**ALAMEDA COUNTY ENVIRONMENTAL HEALTH**  
1131 Harbor Bay Parkway, Alameda, CA 94502

Contaminated Site Case Transfer Form

<b>Site Responsible Party(s)</b>	
Site Name	RO2532 – Fleishman’s Yeast
Site Address	921 98 <sup>th</sup> Avenue, Oakland, CA
Site Phone	na
Site Contractor/Consultant (if available)	ACC Environmental / Geomatrix
Site DBA	na

RE: Response to ACHCSA's August 5, 2005 Comment Letter  
Fuel Leak Site Case No. RO0002532, Former Fleischmann's Yeast Facility  
921 98<sup>th</sup> Street, Oakland, California

Figure Number: 2	Scale: 1" = 50'
Project Number: 6725-001-05	Drawn By: TRB
Date: 4/08/05

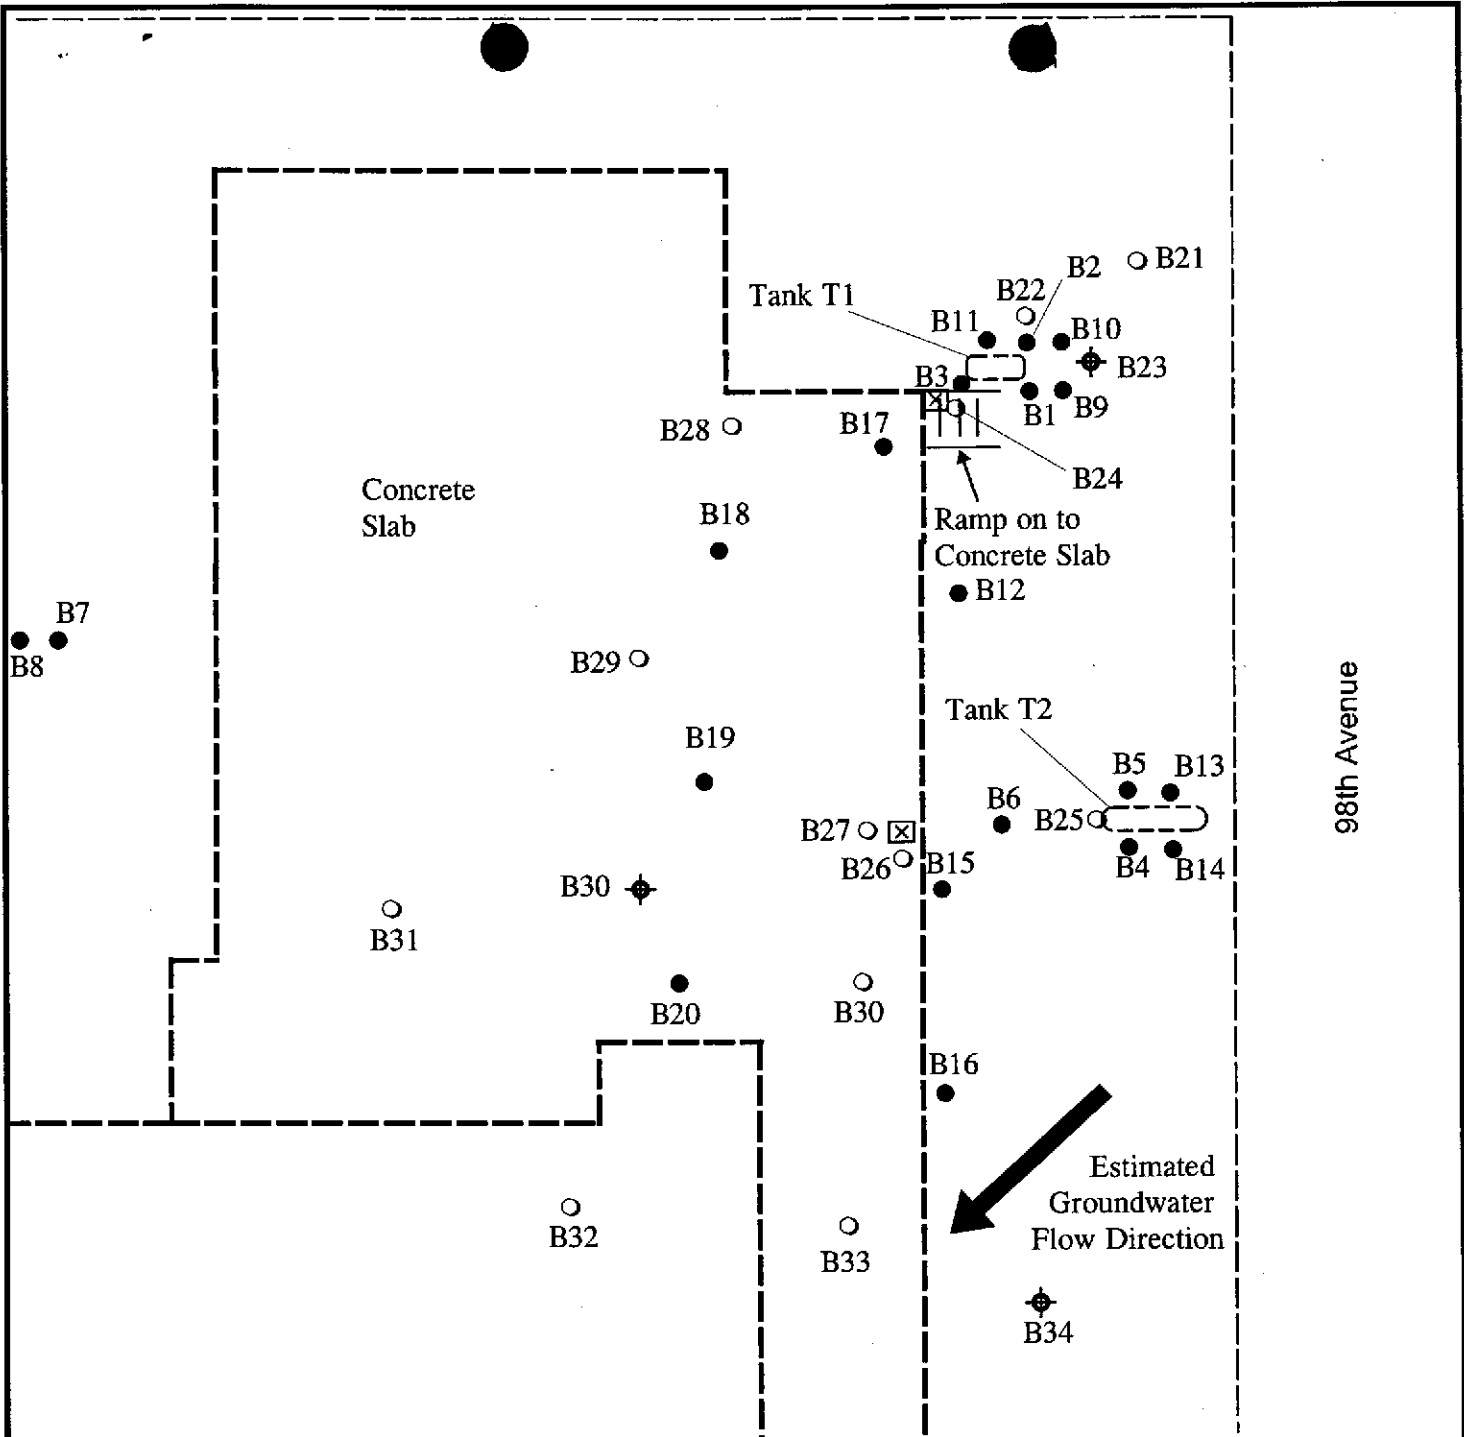
Attached is the PDF of the revised "Proposed Soil Borings" Figure 2 for the former Fleischmann's Yeast facility located at 921 98th Avenue, Oakland, California.
